Appl. No. 10/604,569  
Amdt. Dated 4/26/2005  
Reply to Office action of 04/06/2005

### **REMARKS/ARGUMENTS**

### **Amendments to the Drawings**

Figure 1

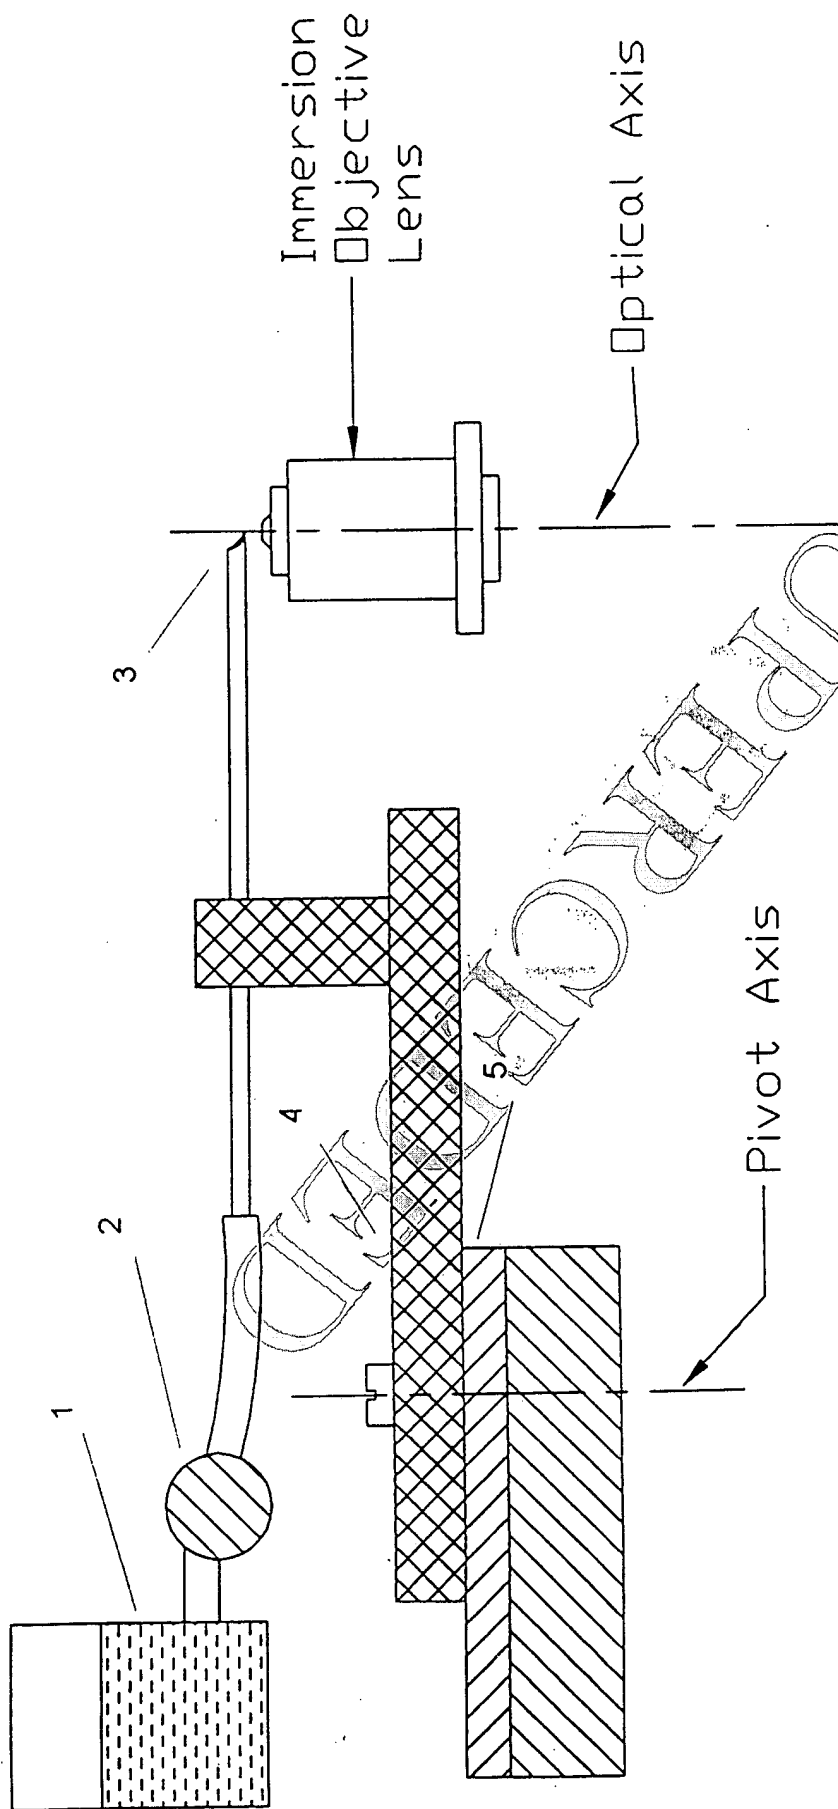
This appendix contains the original Figure 1. The replacement drawing for this figure is contained in the "Amendments to Drawings" section in the body of this submission.

The following figure is a replacement for Figure 1 of the application. This figure has been revised to include the coaxial vacuum channel.
